<b>Case reference</b>	SMC-WDS-001
<b>Application details</b>	Installation of replica Roman distance slab and associated landscaping – Antonine Wall Distance Stones Project
<b>Site address</b>	Forth & Clyde Canal: Old Kilpatrick - Linnvale section, Portpatrick Road, Old Kilpatrick (SM 6778)
<b>Applicant</b> <b>Determining Authority</b> <b>Local Authority Area</b>	GUARD Archaeology Limited Historic Environment Scotland (HES) West Dunbartonshire Council
<b>Reason(s) for notification</b>	Notification Direction 2015 – works to be granted Scheduled Monument Consent by <b>Historic Environment Scotland</b> go beyond the minimum level of intervention that is consistent with conserving what is culturally significant in a monument
<b>Representations</b>	Nil
<b>Date notified to Ministers</b> <b>Date of recommendation</b>	18 June 2020 2 July 2020
<b>Decision / recommendation</b>	Clear

- Scheduled Monument Consent (SMC) is sought for the construction and installation of a wall containing a replica Roman distance slab, associated interpretation and landscaping at the Forth & Clyde Canal: Linnvale to Portpatrick Road, Old Kilpatrick section.

Figure 4 – Landscape proposals

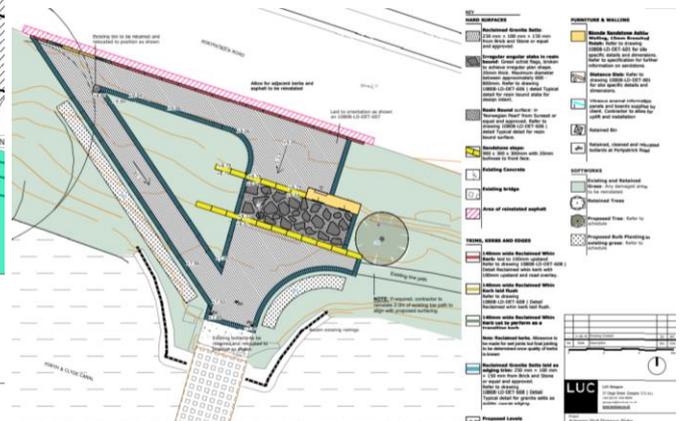
3. The proposed works involve the excavation of an area up to 800mm deep to provide a level surface for foundations, next to the junction of the canal bridge with the towpath and Portpatrick Road (see Figure 4); the construction of a wall (3m long and 1.7m high); and the installation of interpretation panels to explain the importance of the Antonine Wall World Heritage Site, with associated hard landscaping and tree removal and replanting.
